AGENDA
PARKS, RECREATION & NATURAL RESOURCES COMMITTEE
MEETING

Memorandum

Subject: Packet Material for the June 6, 2024 Planning Commission Meeting

1. Zoning Map Amendment to rezone property from O-R, Office Residential Transition District to PUD, Planned Unit Development District.
2. Preliminary plat of 17 residential lots to be known as Kenyon Green.
3. PUD development stage plan for 15 attached townhome lots and a 49-unit apartment building with a height exceeding 42 feet

GRADING PLAN

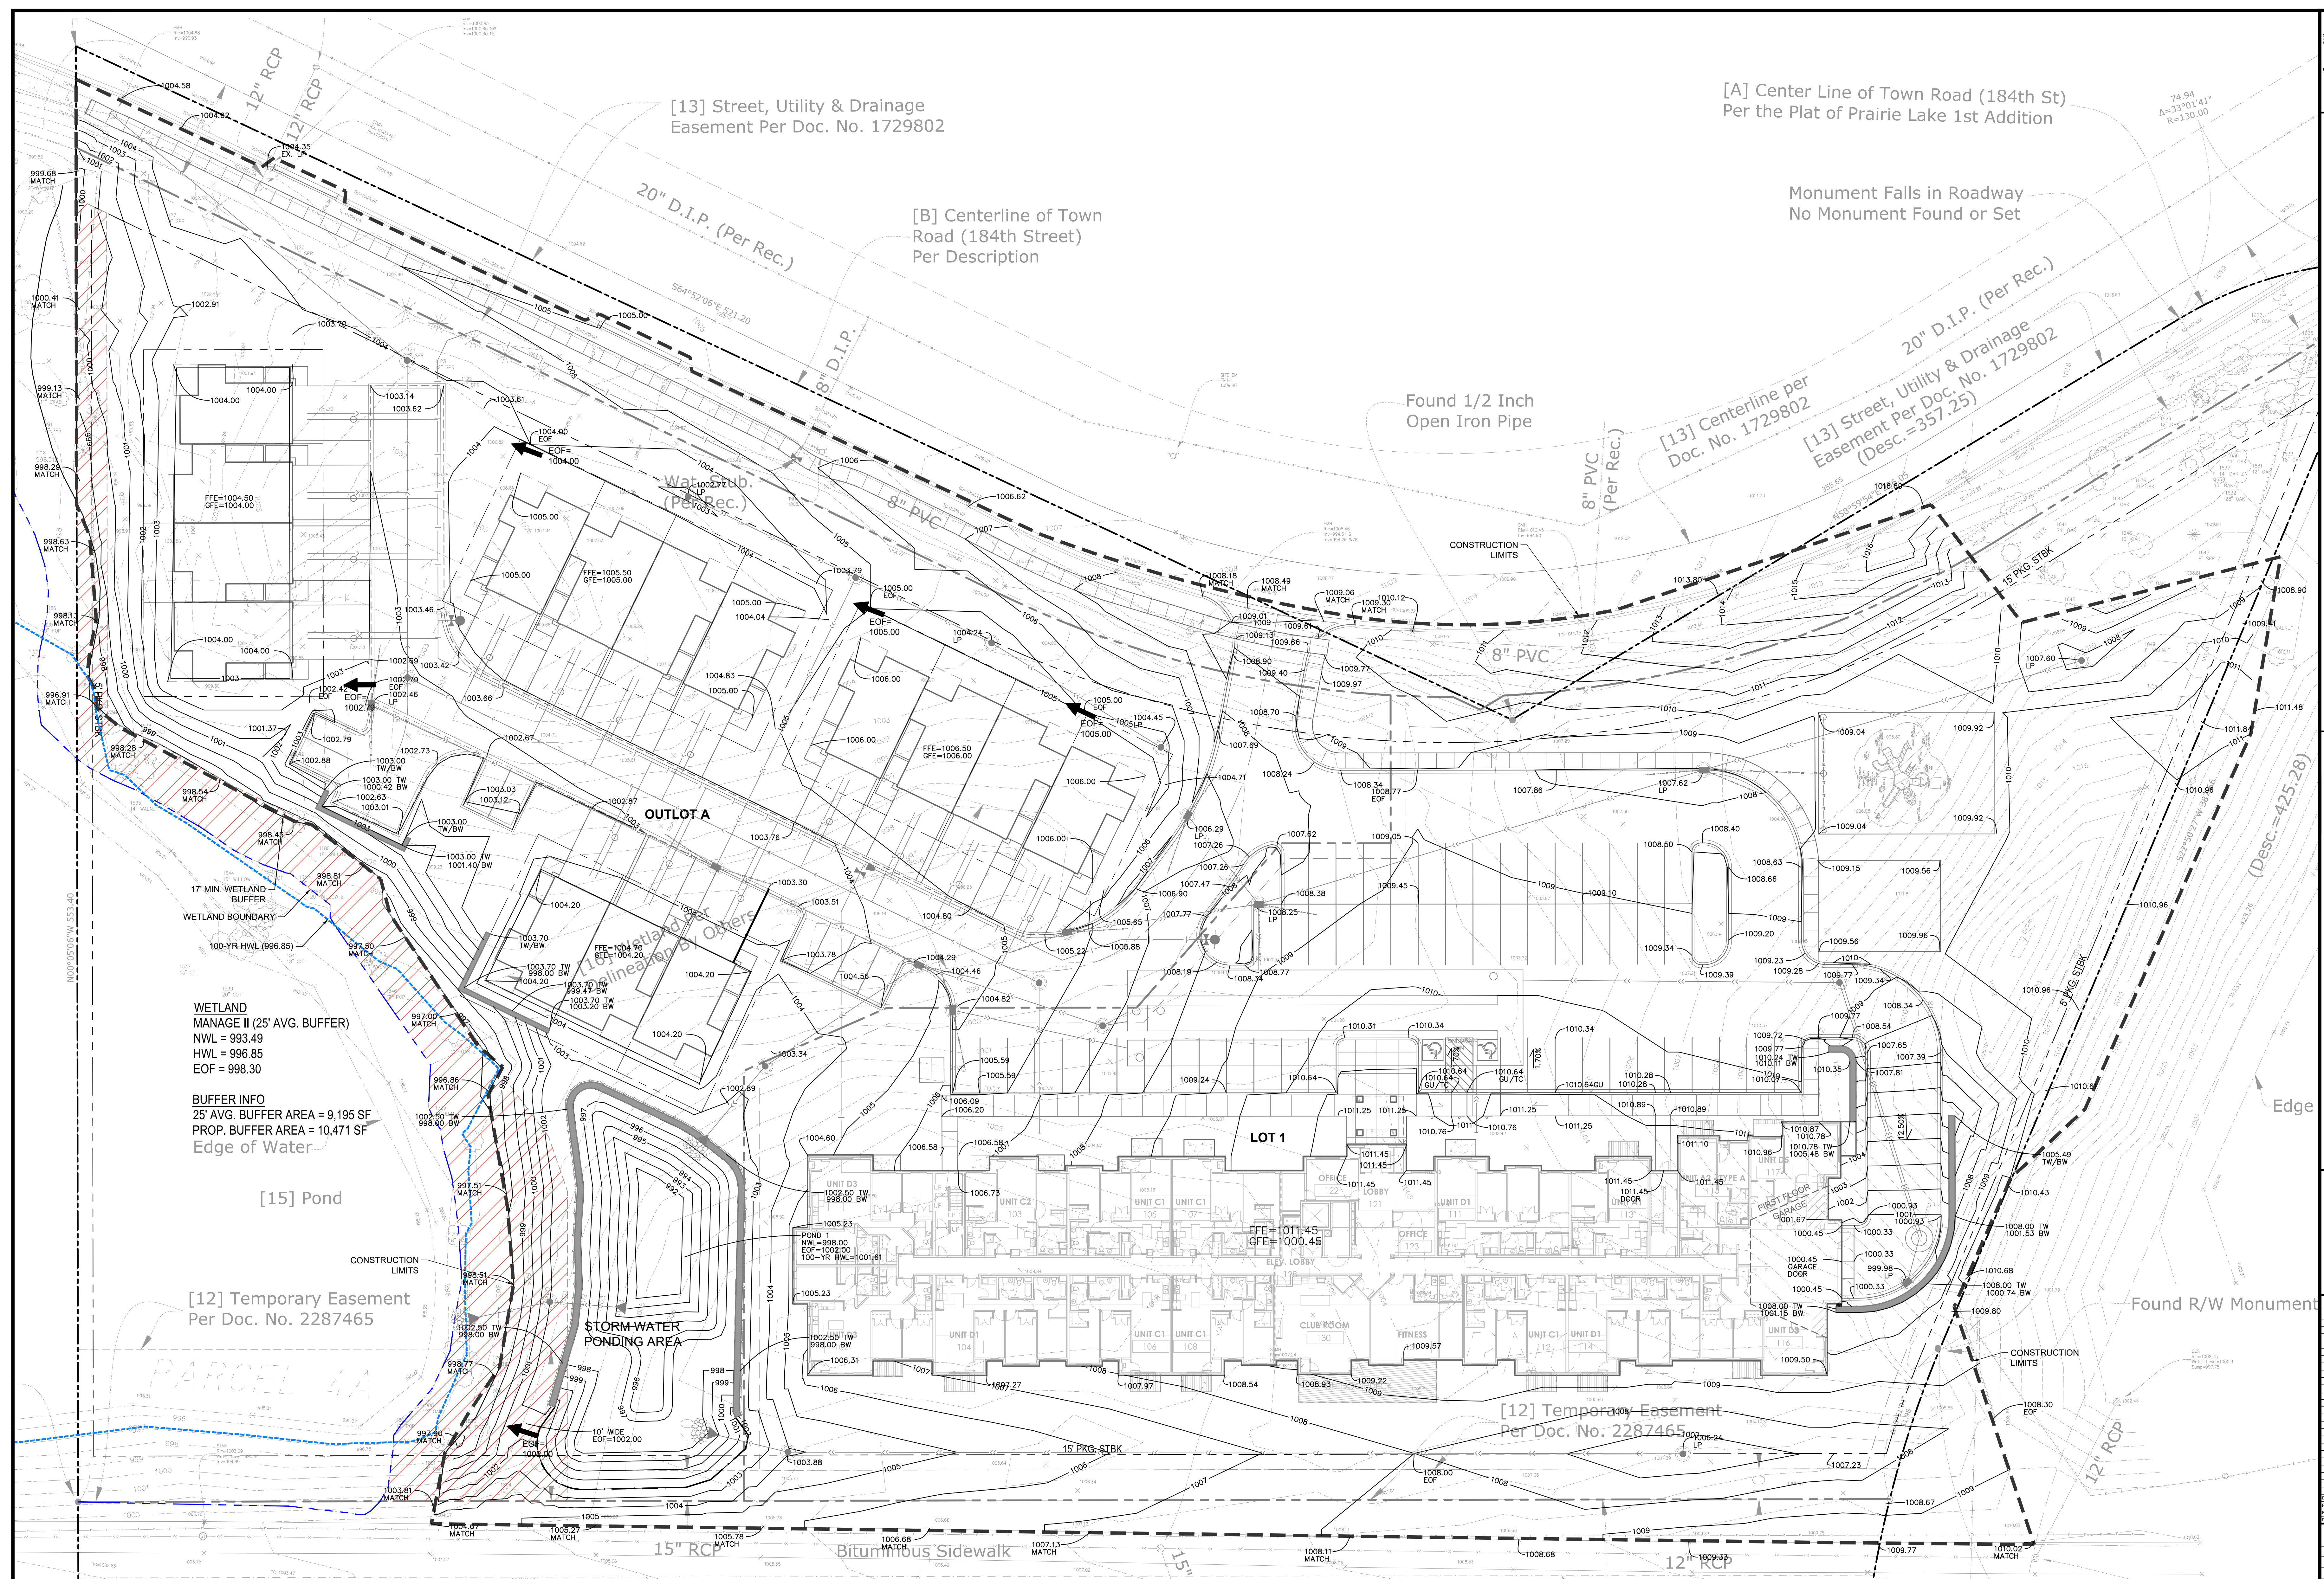
6. Prior to City Council consideration, the landscape plan and grading plan shall be revised to comply with the buffer yard screening requirements adjacent to Kenyon Avenue, 185th Street (CSAH 60) and Interstate 35.

Prior to final plat consideration, the Developer shall submit revised grading plans demonstrating that the lowest floor of all structures are at least three feet above the highest known groundwater table elevation, and consistent with City's zoning ordinance.

LANDSCAPE PLAN

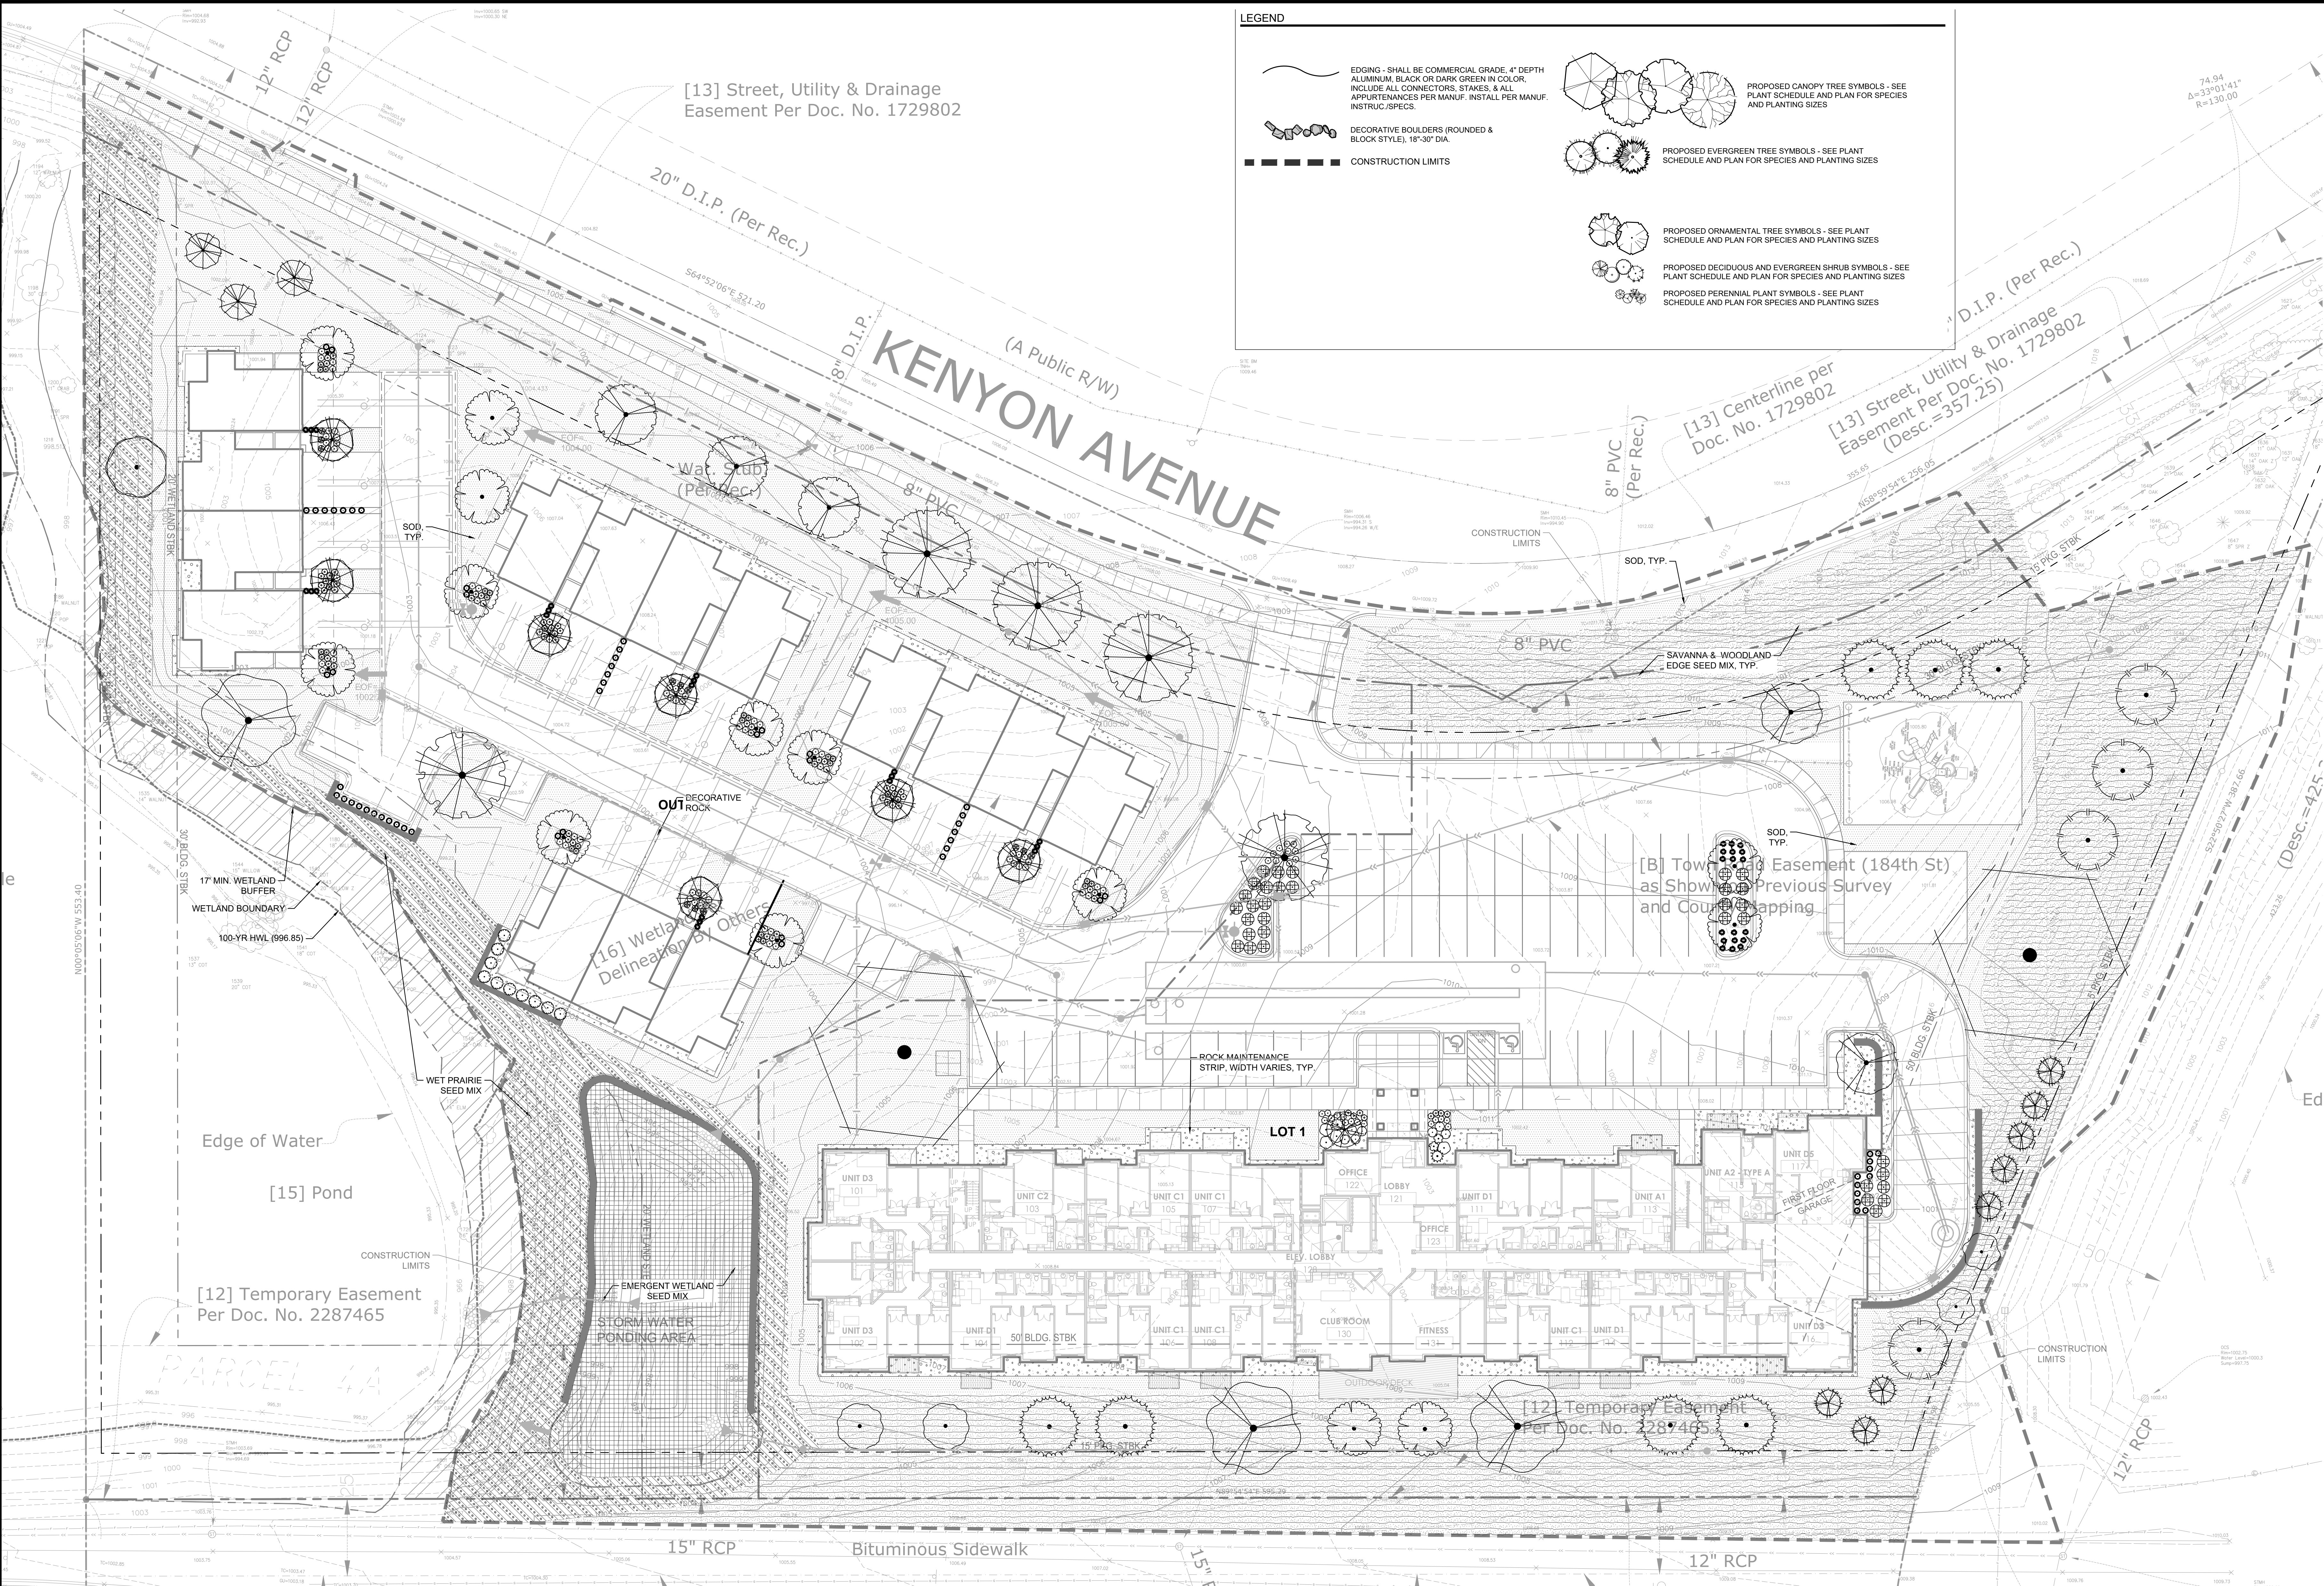
The landscaping plan provides a variety of overstory, ornamental and evergreen trees as well as shrubs at the perimeter of the townhome buildings and apartment building. The landscape plan inventory includes 64 shade, evergreen, and ornamental trees as well as various shrubs, grasses and perennial plants. The City Forester shall review the landscape plan to determine material species and suitability for the site location.
